# Master Sign Plan

## 15-090MSP – BSD Scioto River Neighborhood District

### Big Sandy Super Store – Dublin Village Center

### 6825 Dublin Center Drive

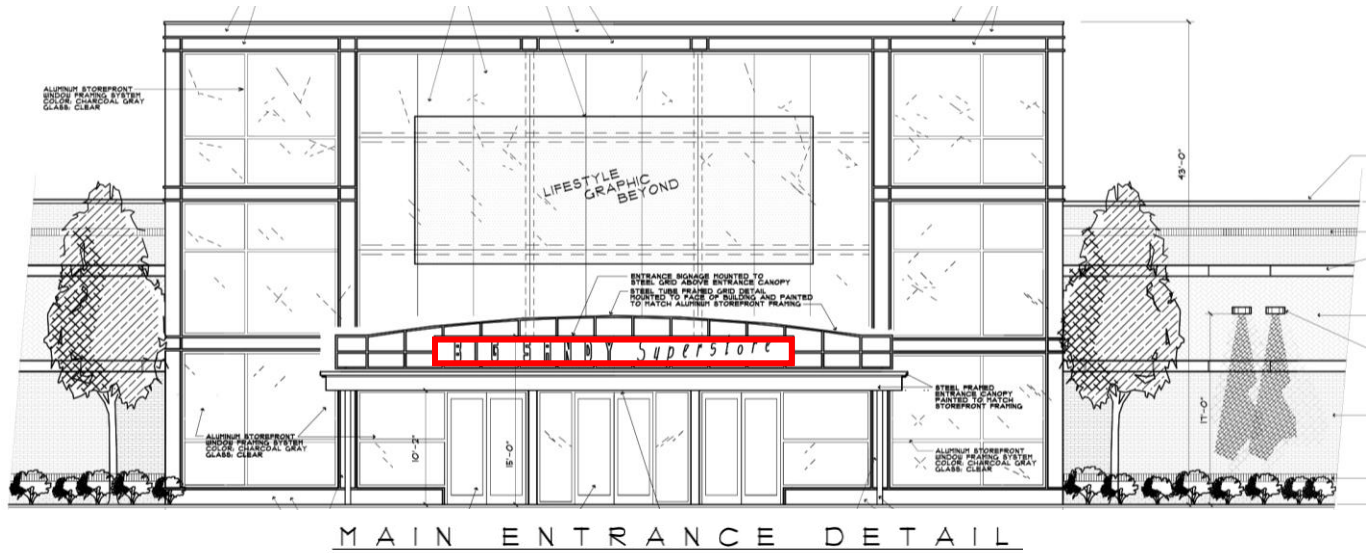
The proposed primary entry sign is 80 sq. ft. in size. It is centered on a metal grid which is integrated into the main entry glass and steel curtain wall system. Code allows 1/2 sq. ft. of sign for each lineal foot of building

wall up to a maximum size of 50 sq. ft. The center section of the building façade could be calculated at 160 lineal feet, which would allow an 80 sq. ft. sign. Due to the scale of the building, the use of the calculated area rather than the maximum limit seems proportional and appropriate.

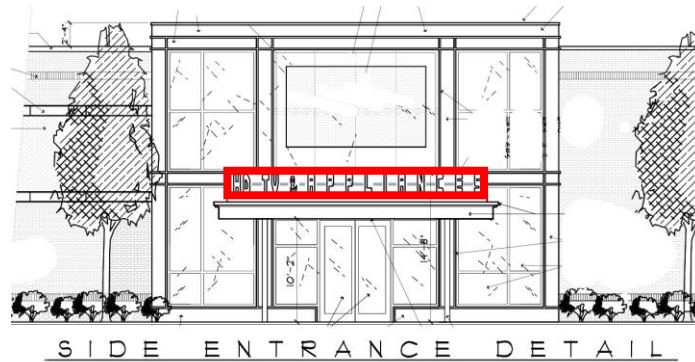
The applicant has made a request to allow two additional wall signs over the two new entries. The 46 sq. ft. secondary entry sign (left) is placed on a reduced size version of the main entry metal grid centered along 140 lineal feet of front façade. The sign is less than the allowable 50 sq. ft. in size.

The 51 sq. ft. secondary entry sign (right) is placed on a reduced size version of the main entry metal grid centered along 140 lineal feet of front façade. The sign is 1 sq. ft. larger than the allowable 50 sq. ft. in size, which is due to a greater number of letters in the sign text.
